**File #:** PC Reso 04-2017  
**Name:**  
**Type:** PC Resolution  
**Status:** Public Hearing  
**File created:** 4/11/2017  
**In control:** Planning Commission  
**On agenda:** 4/26/2017  
**Final action:** 4/26/2017  
**Title:** Resolution to approve a planned development overlay for 5530 South Curtice Street.

**Subject:**  
Resolution to approve a planned development overlay for 5530 South Curtice Street.

**Project Name:** Curtice Street Duplex

**Application Type:** Planned Development Overlay

**Figure 3.**  
**Context for the proposed 16-foot front setback, from the PDO plan set.**

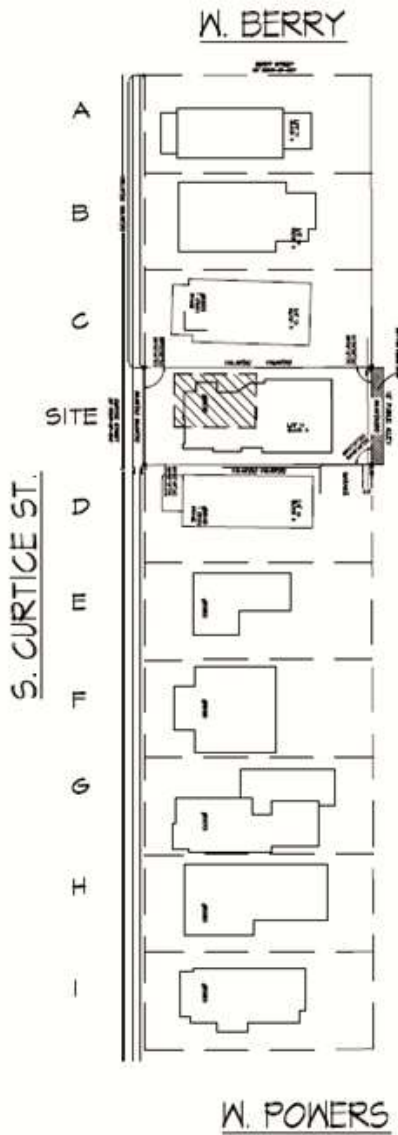
The applicant has provided an analysis of how the proposed setback and height variations are consistent with the existing land use characteristics of the district. (please refer to attached Letter of Intent). In the letter, the applicant states that the proposed modifications would not have a detrimental effect on the character of the neighborhood. With respect to the front setback, the proposed 16-ft. setback appropriate in that it is consistent with the predominant front setback for the block face, which has an average of 15.95-foot front setback, as shown in figure 3. The applicant states that the reduced side setback for the south lot is consistent with the existing character of the block as other homes have narrow side yard setbacks. With respect to height, the applicant states that the proposed 31-ft. tall building, which is 1-ft. greater than the allowable 30-ft. height, will not have a significant visual impact within the neighborhood.

Staff concurs with the applicant's analysis of the proposed setback and height variations with respect to the development pattern in the R-5 district. Further, the development is a benefit to the city: its proposed architectural design is of high quality, utilizing building materials and architectural features that are commonplace on South Curtice Street; the architectural style is based on the craftsman style, which will be complementary to the older homes within the neighborhood, helping to preserving its character; and it provides a new construction option to the neighborhood. Further, the duplex would not impair the intent of the land used code, which allows both single family and multifamily development in the R-5 zone.
